# HISTORIC AND DESIGN REVIEW COMMISSION

May 17, 2017

**HDRC CASE NO:** 2017-180  
**COMMON NAME:** 421-425 E MISTLETOE  
**LEGAL DESCRIPTION:** NCB 863 BLK LOT 14 E 45.5 FT OF 13 & W 4.5 FT OF 15  
**ZONING:** RM-4  
**CITY COUNCIL DIST.:** 1  
**APPLICANT:** Ricardo Turrubiates/Tarramark Urban Homes  
**OWNER:** K/T TX Holdings, LLC  
**TYPE OF WORK:** Construction of housing development

SCALE: 1/4" = 1'-0"

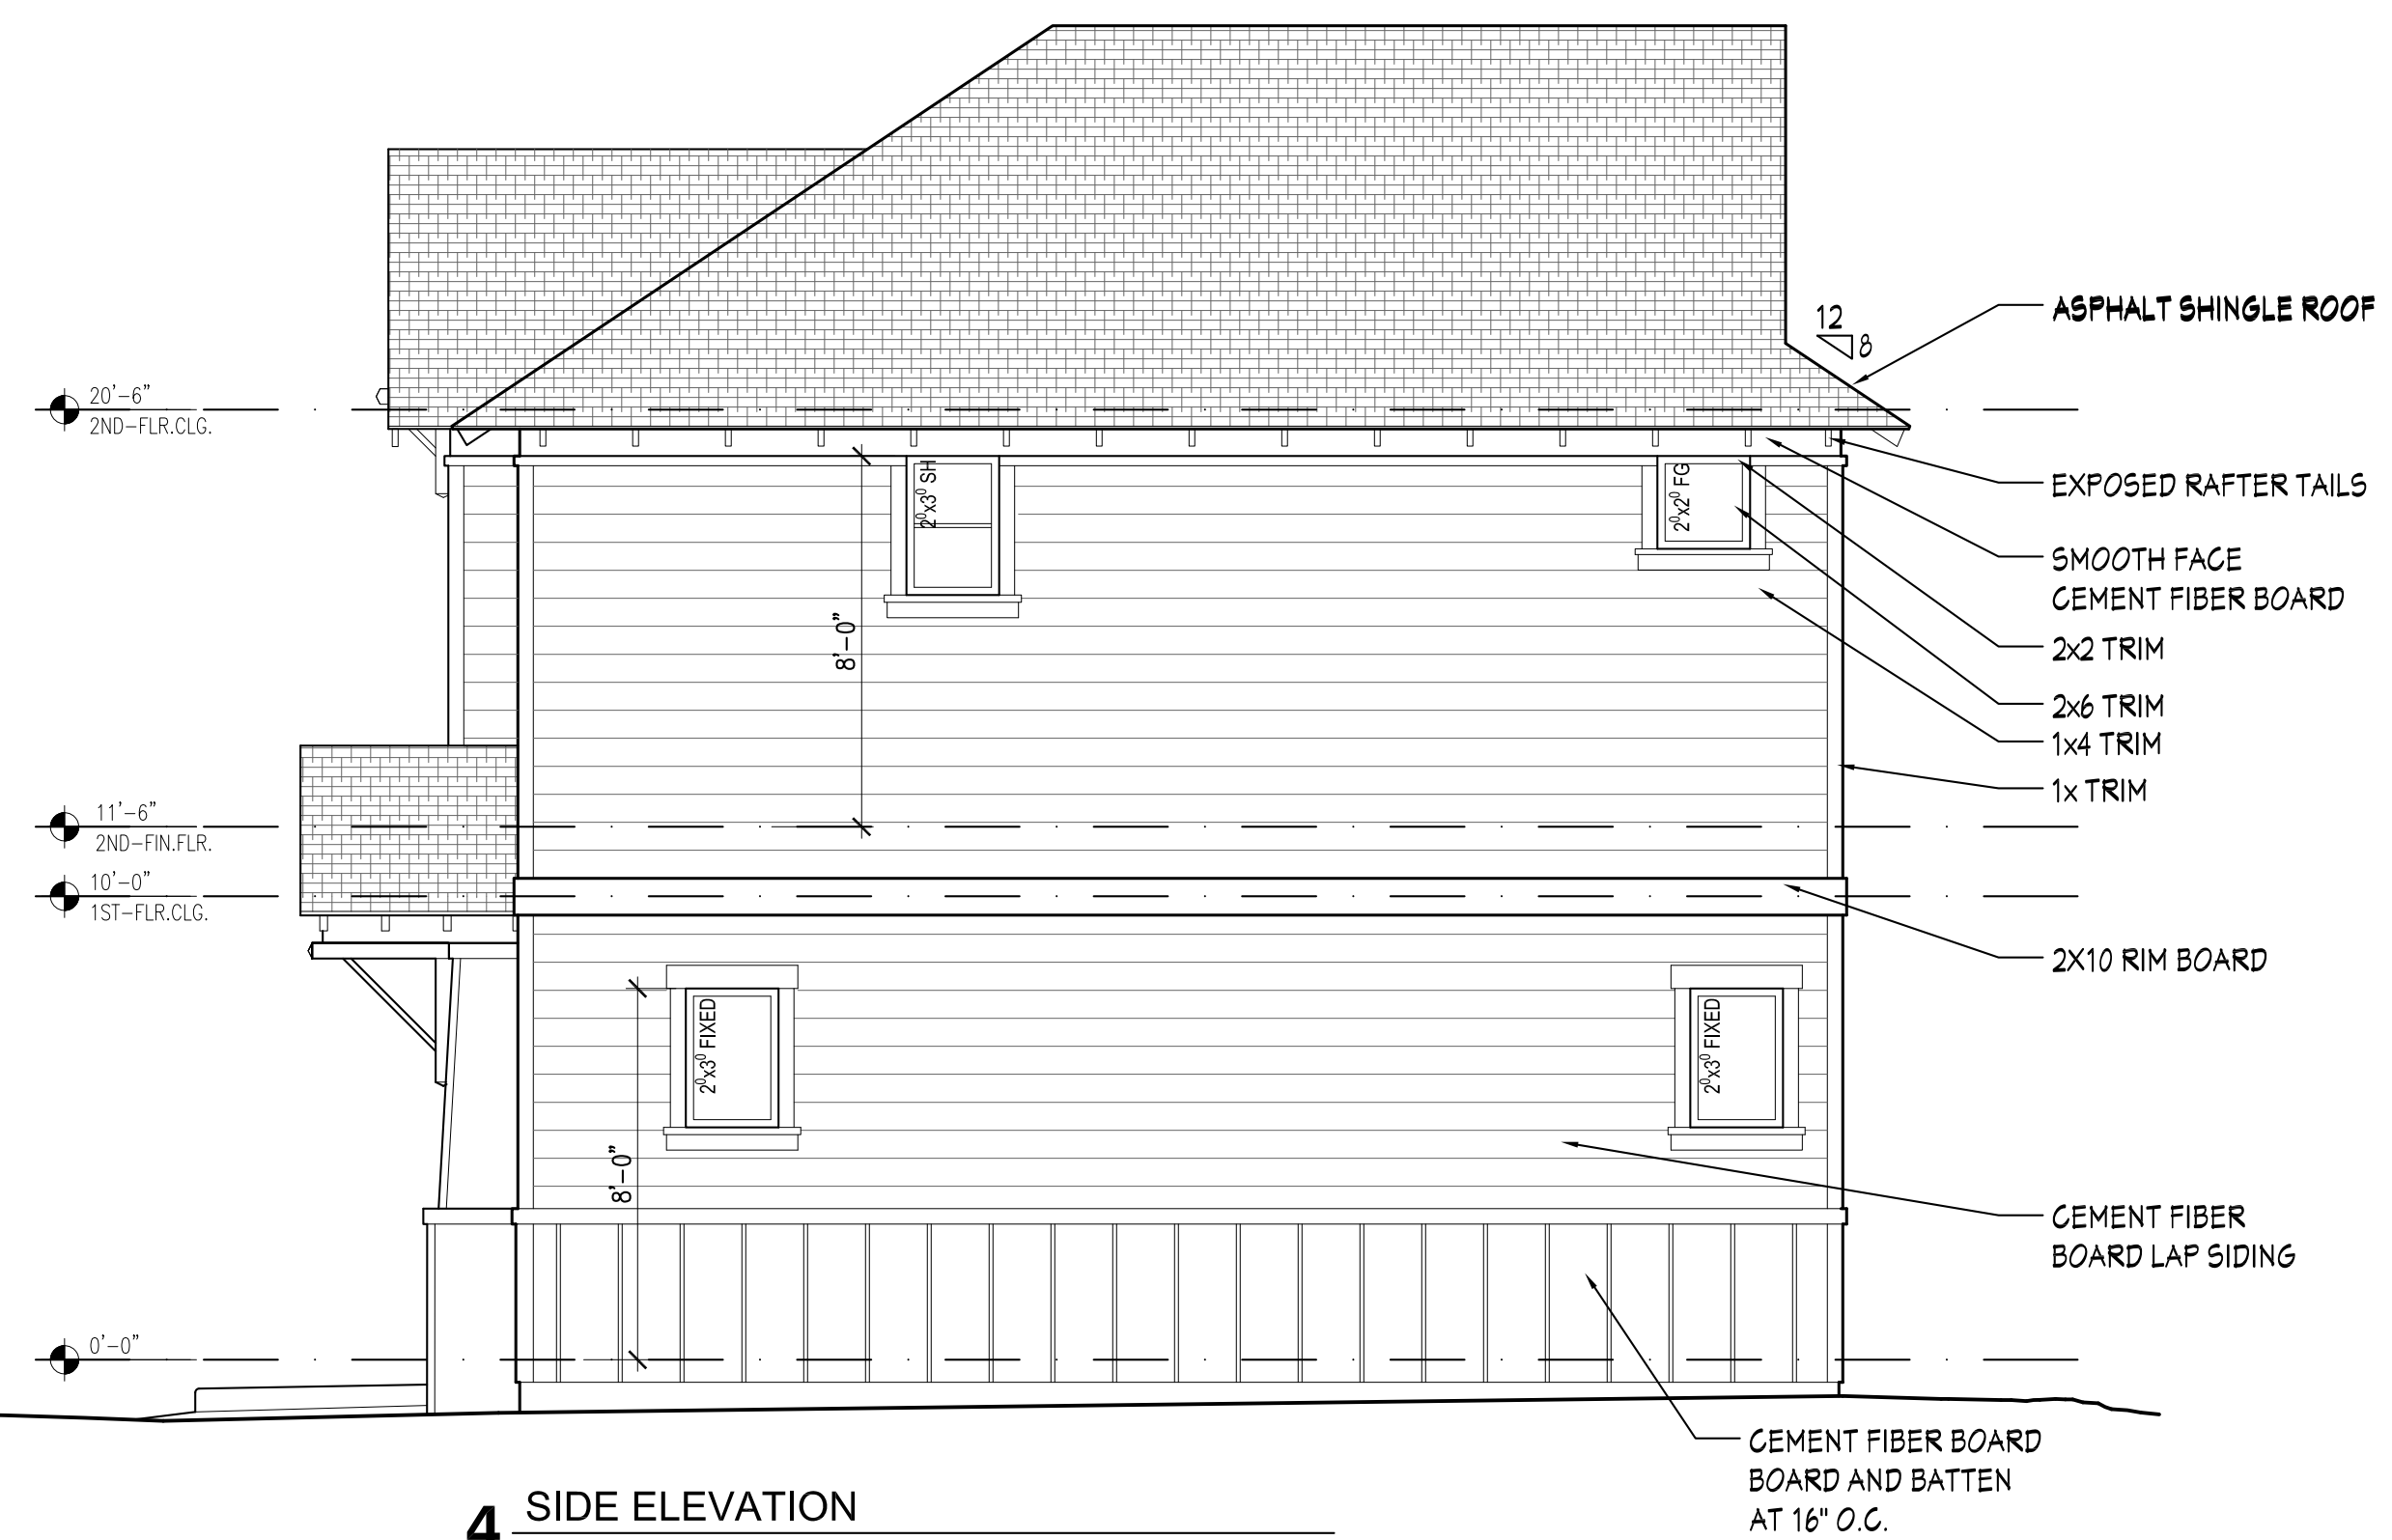
- g. **WINDOW AND DOOR PLACEMENT** – The proposed design for Building 1, Building 2, and Prototype 4.2B include the placement of windows and doors, including their trim, directly abutting rim board, roof trim pieces, and/or fiberboard on every elevation. This direct adjacency of materials and façade elements is not typical of historic approaches to fenestration. Additionally, on some elevations, the blank wall space between openings exceeds the continuous wall space recommendations in the guidelines.

- j. BUILDINGS 1 AND 2 – Building 1 and Building 2 were submitted in the proposal heard by the HDRC on April 19, 2017. In staff recommendations, as well as at the hearing, it was noted that the windows did not comply with the OHP Window Policy document. It was also noted that these buildings did not feature full porches with two columns. The suggested modifications have not been made since the last hearing.

- a. The applicant explores designs that respond to the context of the district versus utilizing designs that are built or proposed in other parts of the city.
- b. The applicant explores 1.5 story options or prototypes with a modified roof pitch to respond to the dominant historic massing context of the neighborhood.
- c. Fenestration patterns on all prototypes are revised to be more consistent with the size and placement common of historic facades in the district.
- d. That the front porch configuration for Prototype 1436 is modified to include two columns that project from the façade and engage the streetscape.
- e. That the proposed windows are true divided lites or a 1 over 1 configuration with wood screens featuring divided lites to reflect window configurations common in the district and the proposed modern Craftsman approach.
